# **REVISED STUDY PLAN**

### **TURNERS FALLS HYDROELECTRIC PROJECT (NO. 1889)**

### **NORTHFIELD MOUNTAIN PUMPED STORAGE PROJECT (NO. 2485)**

*Study 3.3.19 - Evaluate the Use of an Ultrasound Array to Facilitate Upstream Movement to Turners Falls Dam by Avoiding Cabot Station Tailrace*

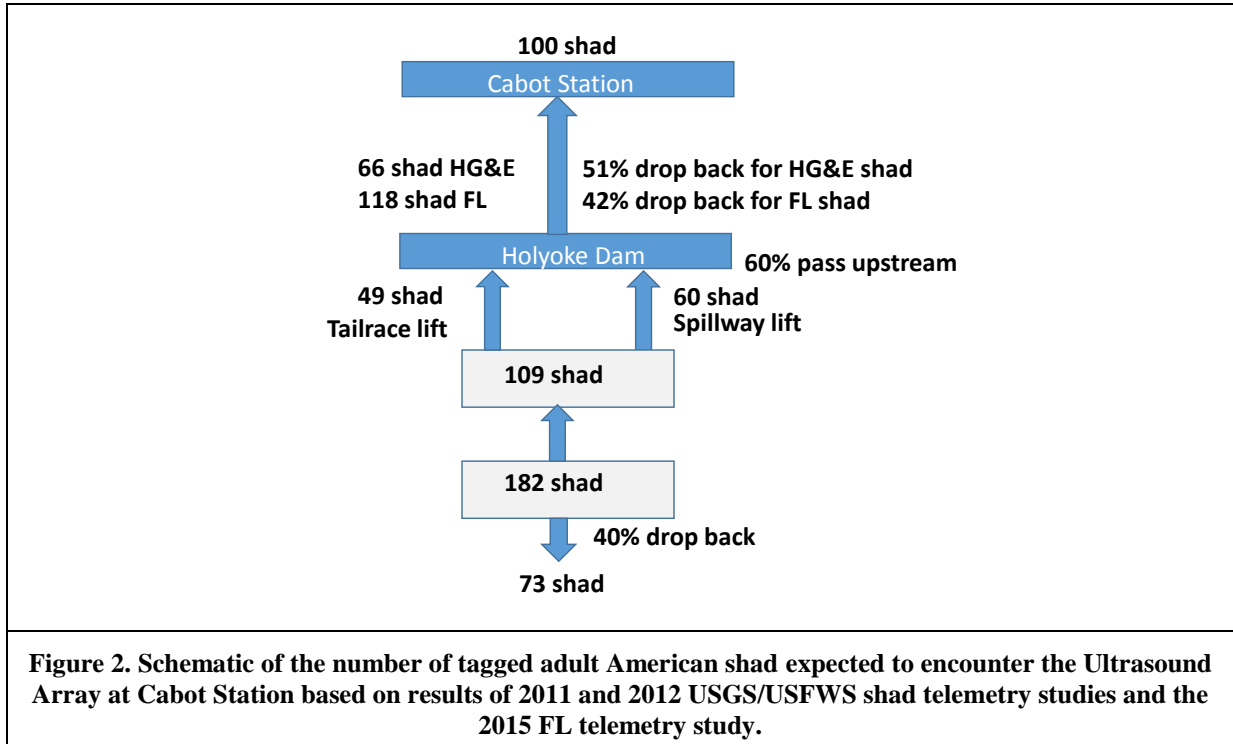
The additional radio antennas at the dam (note under Figure 2) should detect fish in the vicinity of the dam and in close proximity to the spillway entrance. An antenna should also be located at Station #1 to detect any delay caused by the operation of Station #1 and to detect fish movement in the bypass.

Figure 2, showing the number of shad available from the HG&E release, incorrectly assumes that all 109 shad that arrive at Holyoke will pass. Results from the whole river study indicate that 60.7% of lower river released shad that arrive at Holyoke pass. As such, 66 shad from the HG&E release will pass the dam. Using the 0.58 rate of shad tagged at the Holyoke lift, if 100 shad are tagged at the lift 106 would

**Figure 3: Proposed Telemetry  
Sites for Ultrasound Array  
Study**

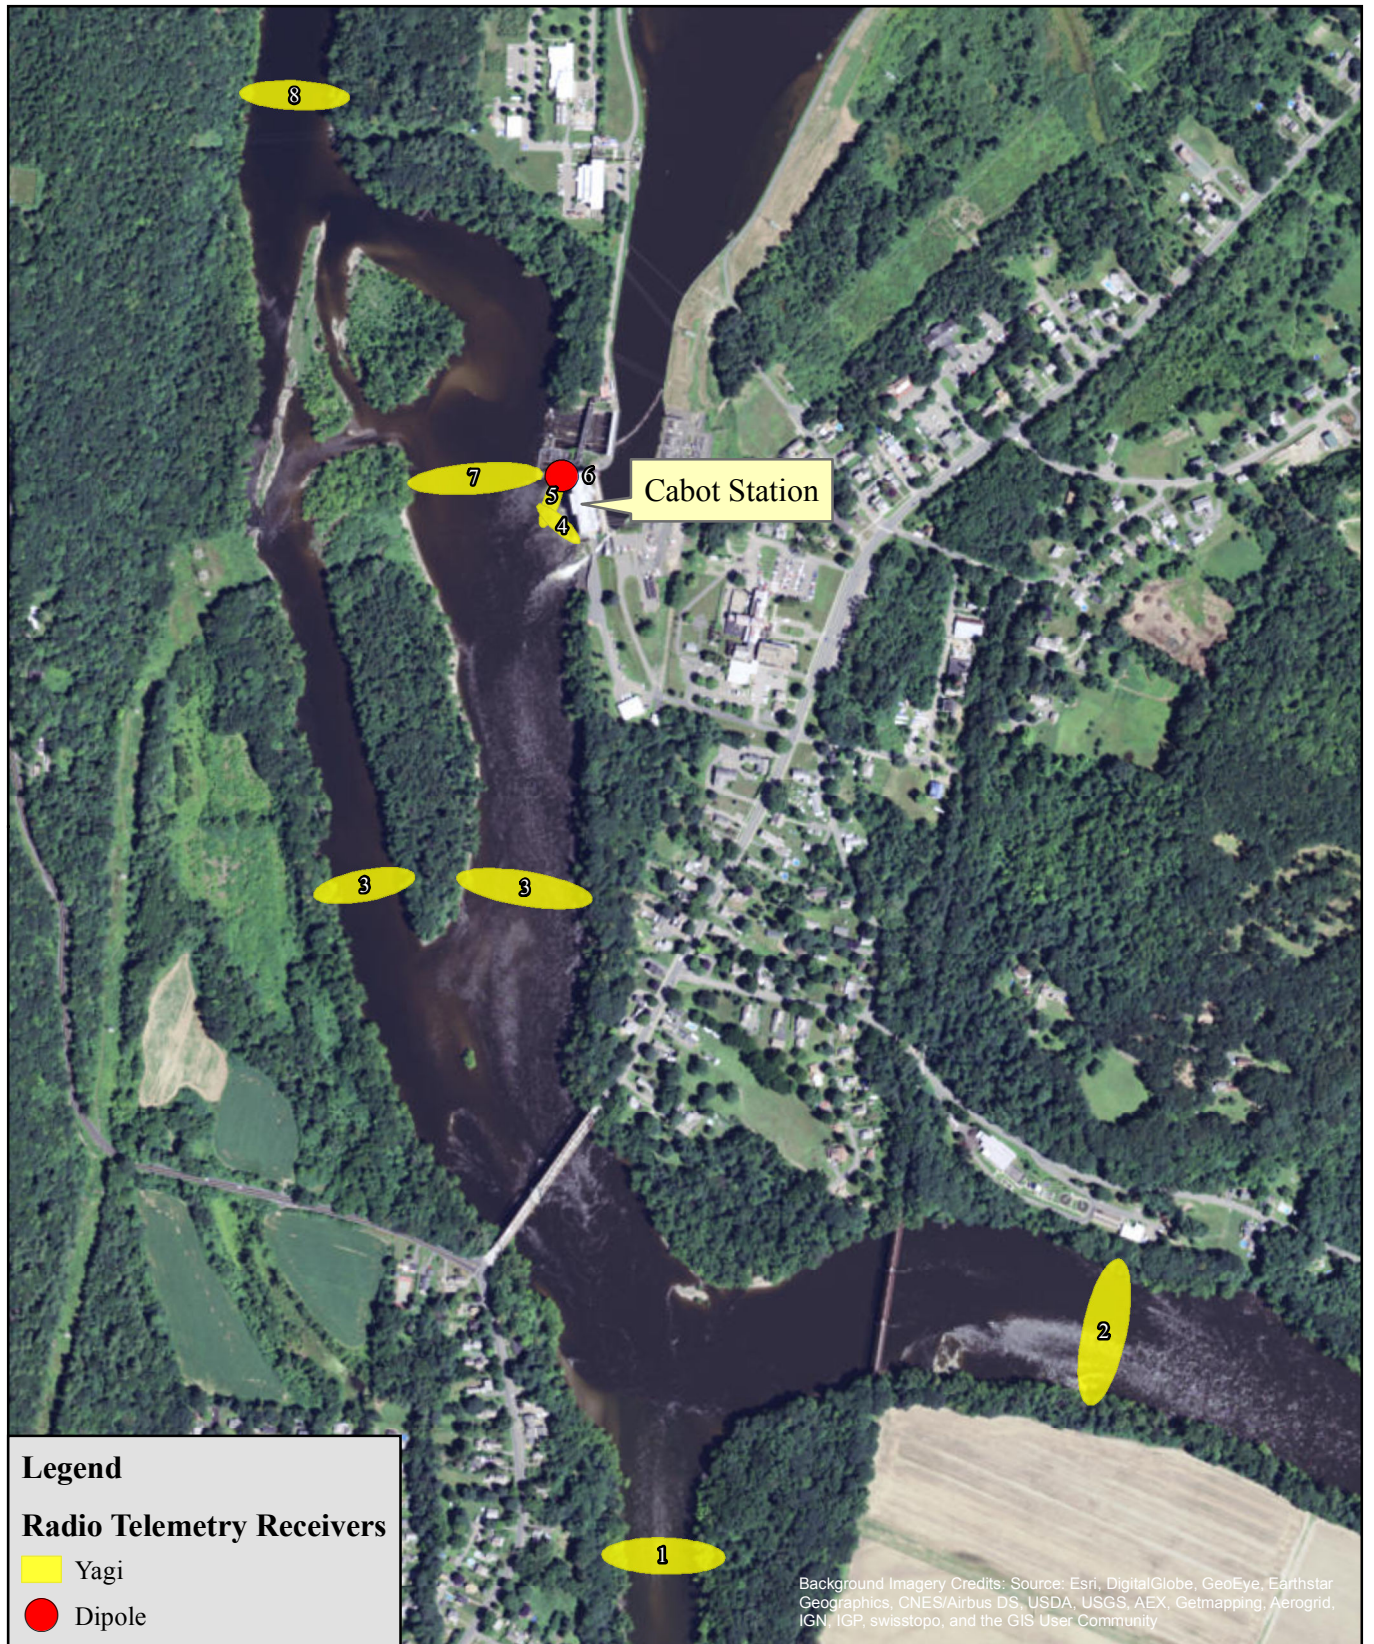
Since the thrust of the Study is aimed at getting fish up through the Bypass, I question why just three monitoring sites are suggested to be deployed upstream of Cabot Station itself.

- Data should also be provided on the hourly operation and number of gates open at the Emergency Spill Gates off the Canal at Cabot.
- I'd suggest removing the monitor upstream of the mouth of the Deerfield and **placing it at the Rock Dam pool**, a site where shad--and anglers have a historic presence in the Bypass. The agencies, as well as the anglers, are concerned with finding out where fish gather and stall in this reach on their way northern MA, VT, and NH.

- Another monitor needs to be placed at Station 1, another known fishing site. I interviewed a fisherman there last year with Station 1 running. There were scores of fish visible, treading water in the outflow. He flatly said there are "always shad here" when Station 1 is generating.
